# SUBDIVISION REPORT - CONCEPT/USE ON REVIEW

▶ **FILE #:** 1-SA-19-C **AGENDA ITEM #:** 10  
1-D-19-UR **AGENDA DATE:** 1/10/2019

▶ **SUBDIVISION:** THE MOODY PROPERTY  
▶ **APPLICANT/DEVELOPER:** JRG DEVELOPMENT, LLC  
**OWNER(S):** JRG Development, LLC

**1-SA-19-C / 1-D-19-UR  
CONCEPT PLAN/USE ON REVIEW**

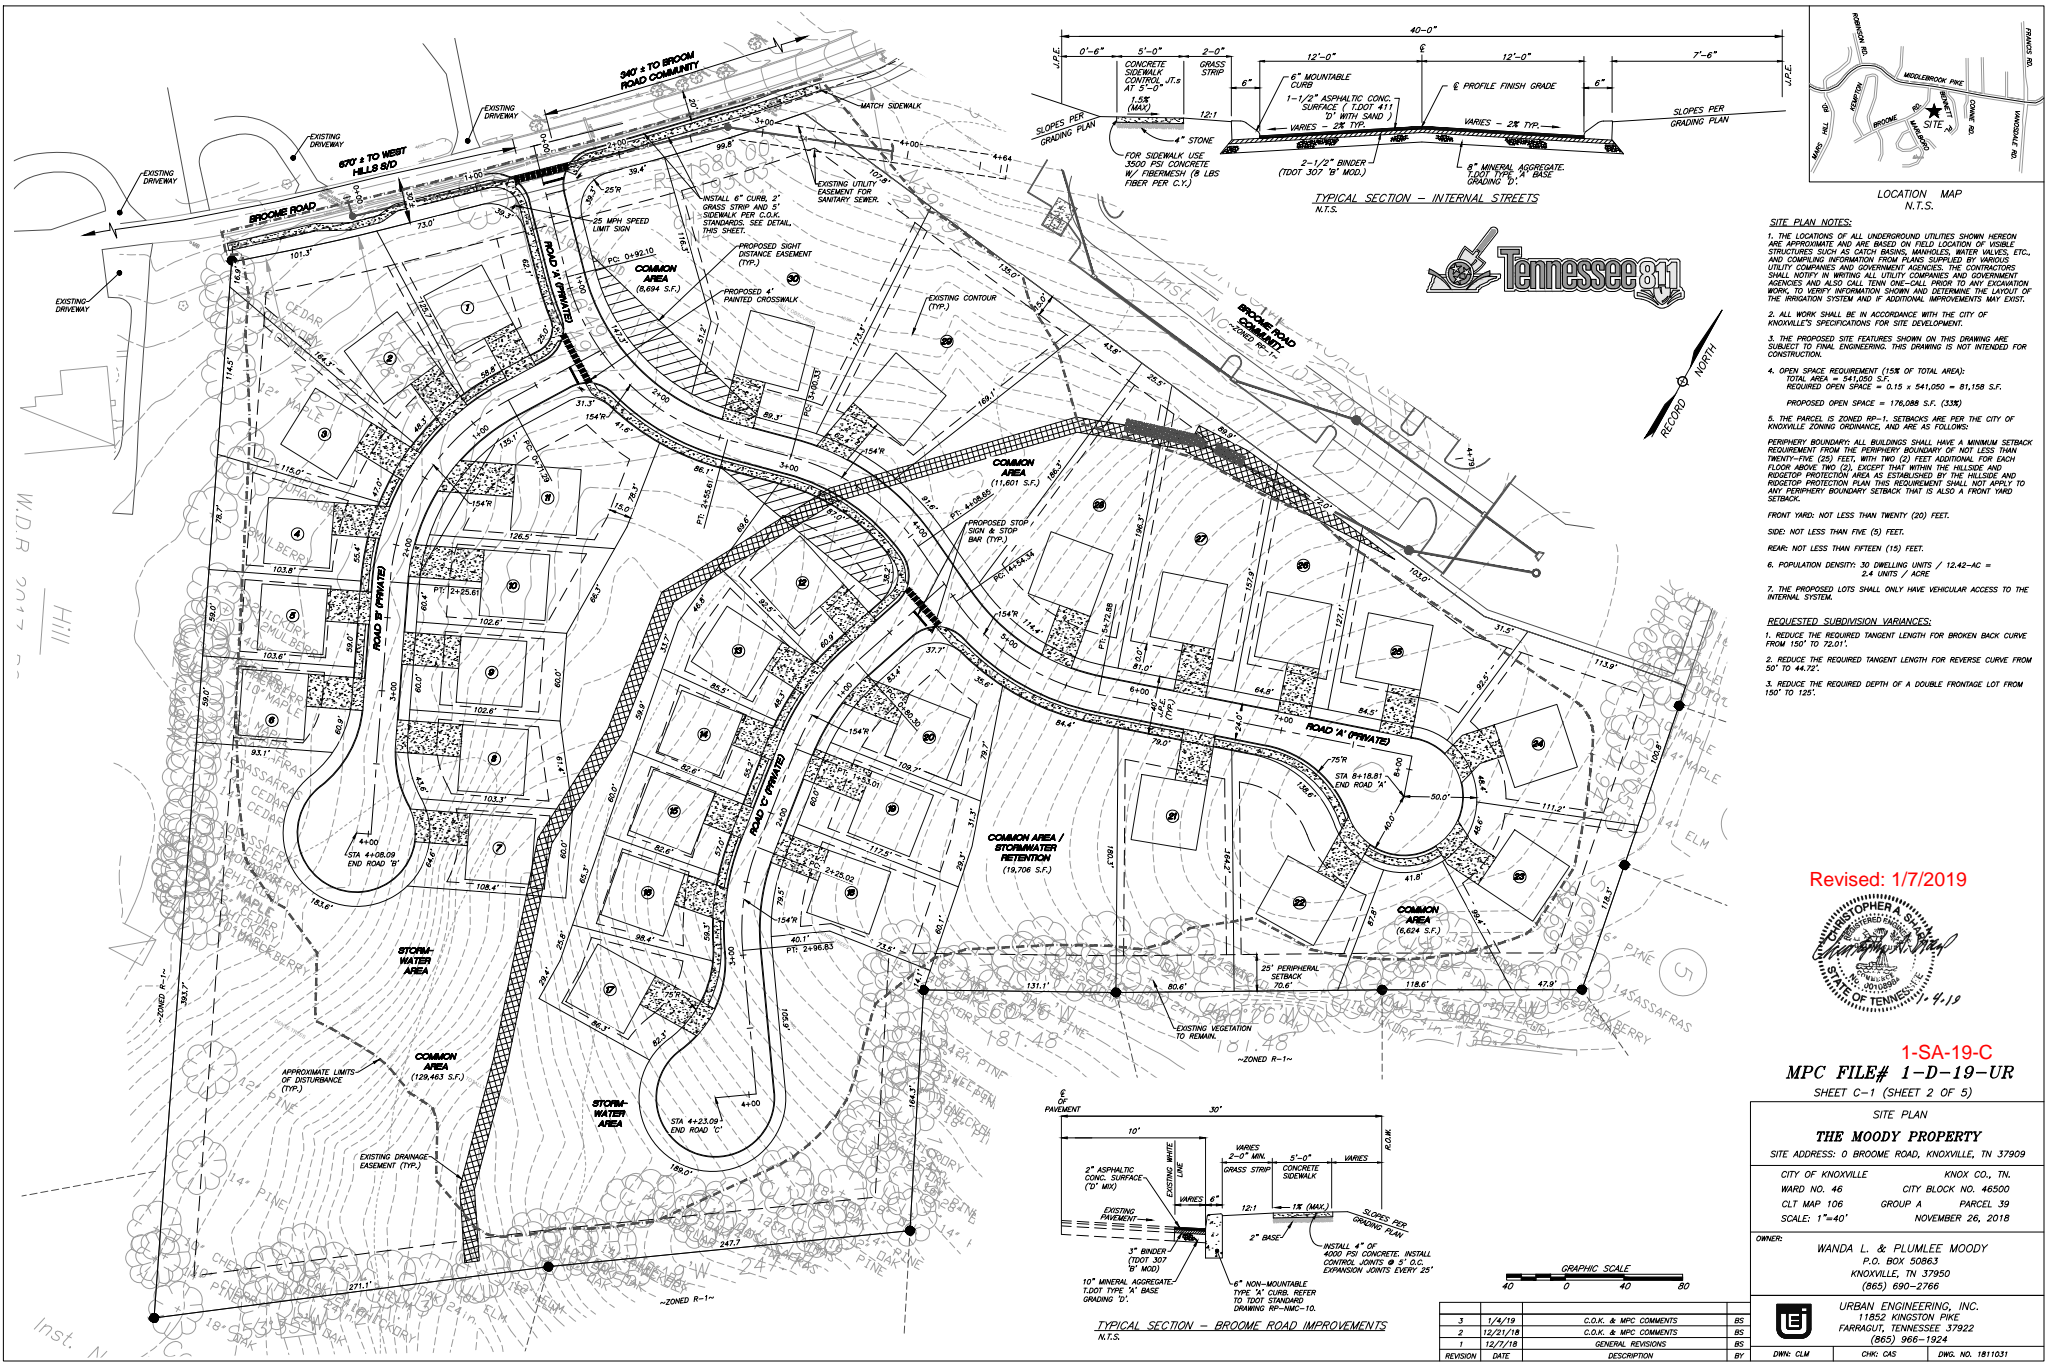
▶ **SUBDIVISION VARIANCES REQUIRED:**  
1) Reduce the required tangent length of a broken back curve from 150' to 72.01' at STA 1+53.01 on Road "C".  
2) Reduce the required tangent length of a reverse curve from 50' to 44.72' at STA 4+08.65 on Road "A".  
3) Reduce the required depth of a double frontage lot from 150' to 125' along the shortest lot line for Lot 2.

▶ **APPROVE** variances 1-3 because the site's topography and shape restrict compliance with the Subdivision Regulations and the proposed variances will not create a traffic hazard.

8. Widening Broome Road to a minimum 20' pavement width from the Road "A" intersection to the location where the adjacent development to the northeast will end their road widening, and as approved by the City of Knoxville Department of Engineering.

9. Installation of sidewalks as identified on the Concept Plan. Sidewalks shall meet all applicable requirements of the Americans with Disabilities Act (ADA) and the City of Knoxville Department of Engineering. A bond shall be provided to the City of Knoxville Department of Engineering by the developer in an amount sufficient to guarantee the installation of the sidewalks. The sidewalk along Broome Rd. shall tie into the sidewalk being installed on the adjacent property to the northeast.

11. Installing multiple retention ponds in the approximate locations as shown on the Concept Plan. Additional retention ponds of similar or smaller size may be approved by Planning Commission staff and the City of Knoxville Department of Engineering if the proposal meets the intent of this approval to utilize multiple small retention ponds.

This staff report was revised based on the revised Concept Plan submitted on 1/7/2019. The condition requiring the roads to be revised to meet the Minimum Subdivision regulations (former condition #11) has been removed because the horizontal curve radii now meet the minimum requirements. There are two other road design variances that staff is recommending approval of.

INTERSECTION OF ROADS A & B SCALE: 1"=40'

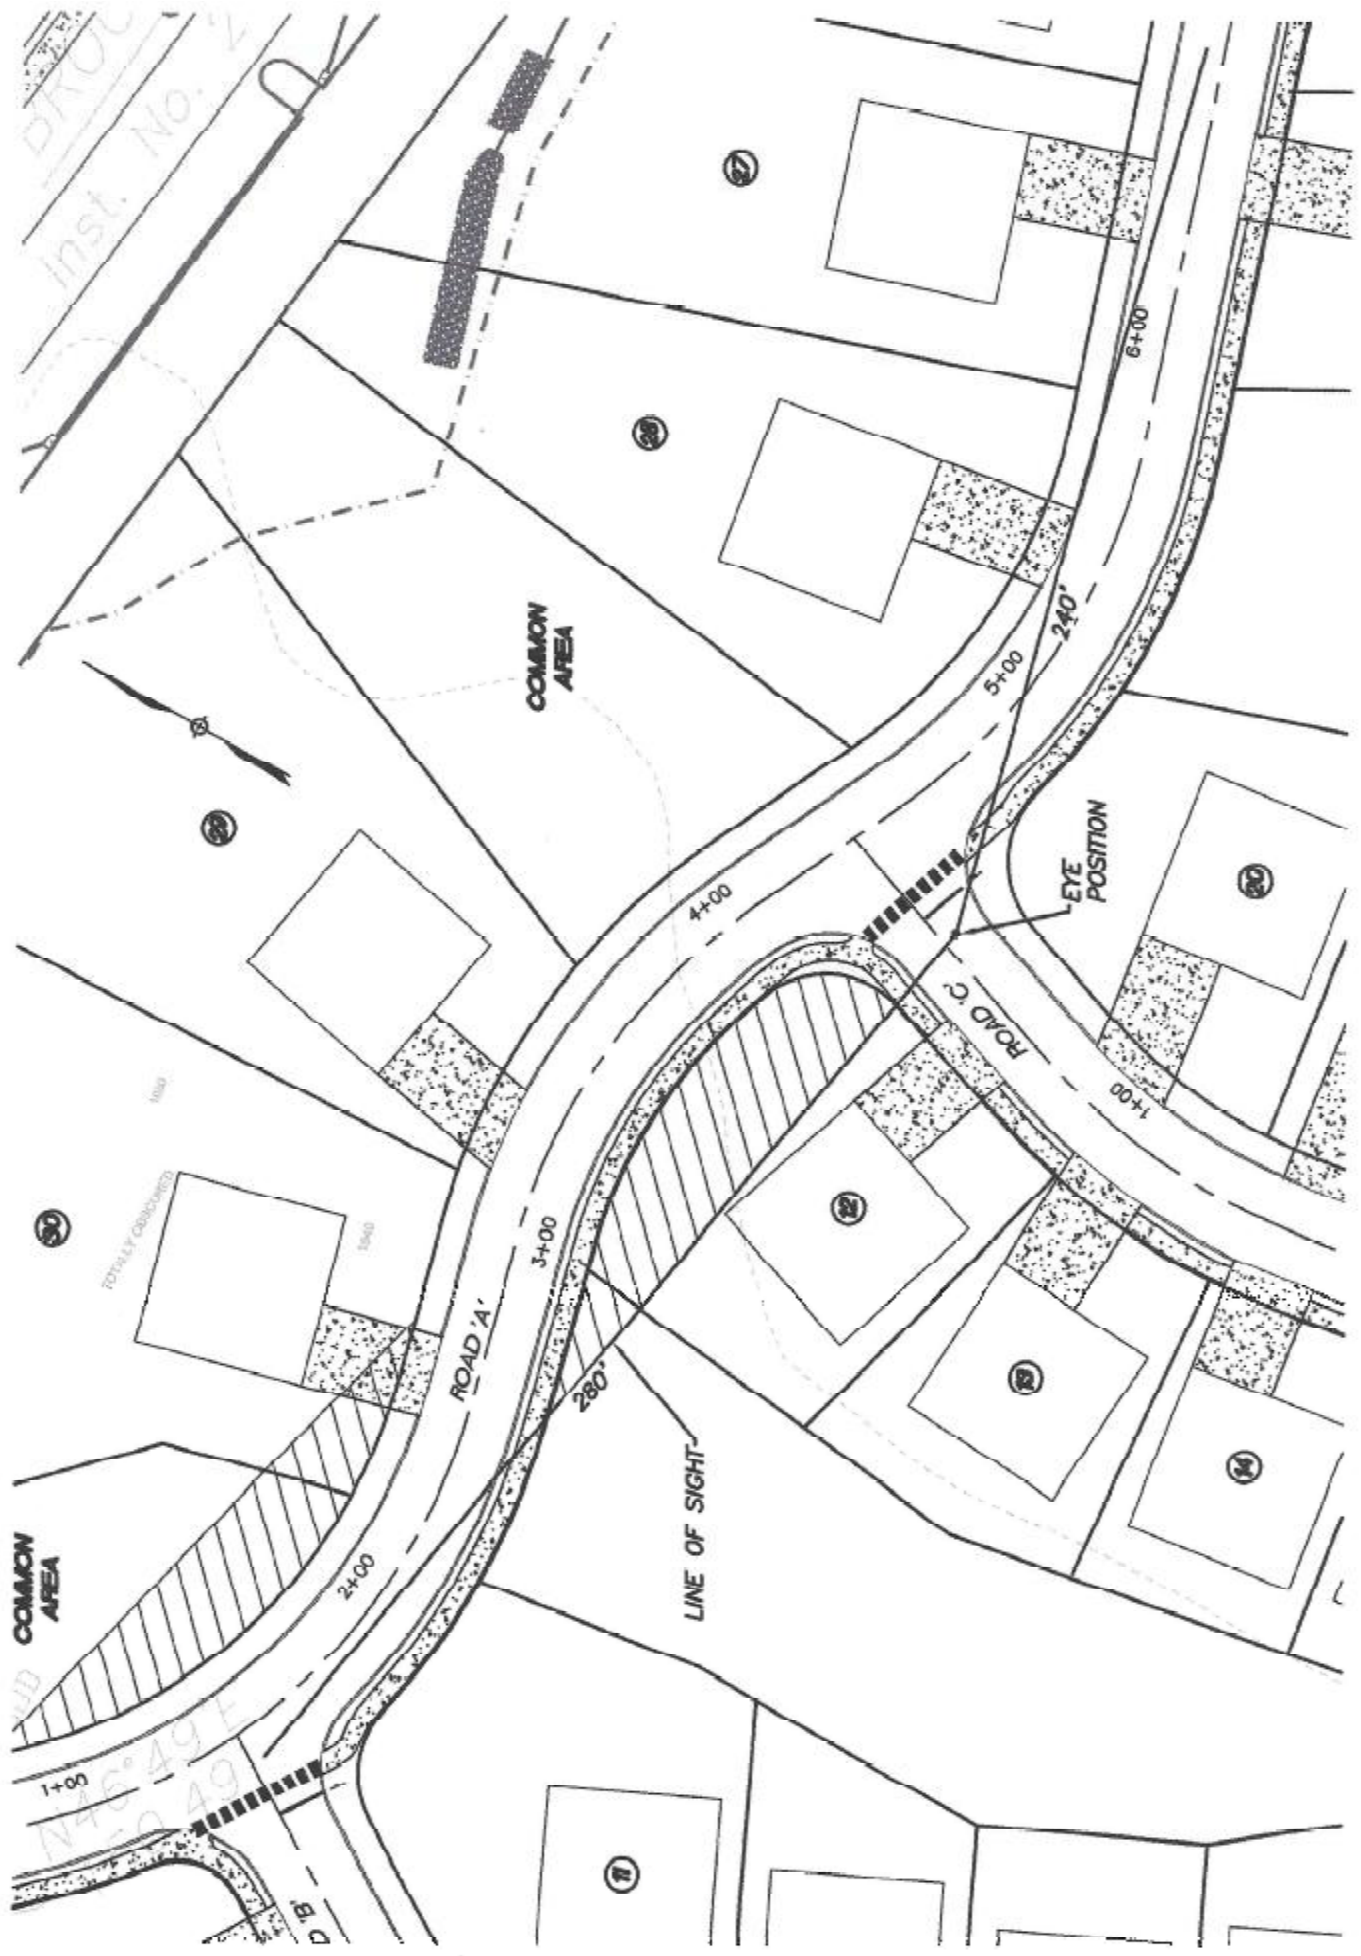
Sight distance was measured at the proposed entrance location show on Sheet C-1 of our recent Use on Review Submittal. Broome Road is a local collector with a posted speed limit of 30 MPH. Per AASHTO, the required intersection sight distance for a vehicle turning left onto the thru road is 335 feet. The required intersection sight distance for a motorist turning right is 290 feet. The minimum stopping sight distance for a 30 MPH roadway is 200 feet.

Facing southwest, there is in excess of 600 feet of available sight distance. Facing Northeast, there is approximately 350 feet of available sight distance. Attached to this letter are photographs taken from the entrance location facing both directions along with GIS maps that show the approximate lines of sight. Please do not hesitate to contact me if you have questions.
